WASHINGTON PUBLIC POWER SUPPLY SYSTEM

NUCLEAR PROJECT NO. 2

AMENDMENT TO FACILITY OPERATING LICENSE

Amendment No. 138  
License No. NPF-21

Figure 3.1.5-2

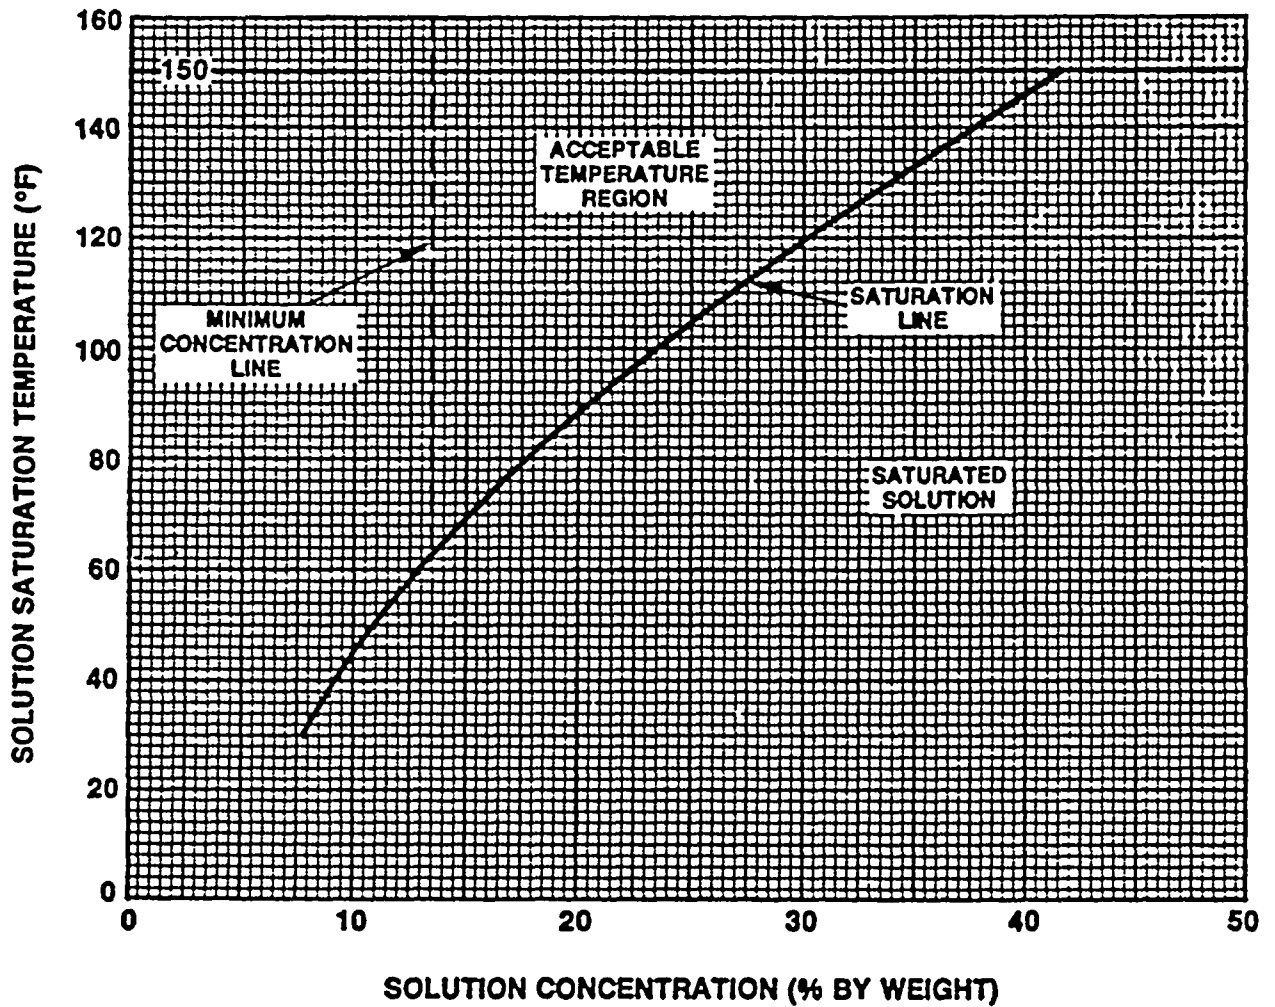
Replace the following page of the Appendix A Technical Specifications with the enclosed page. The revised page is identified by amendment number and contains vertical lines indicating the areas of change. The corresponding overleaf page is also provided to maintain document completeness.
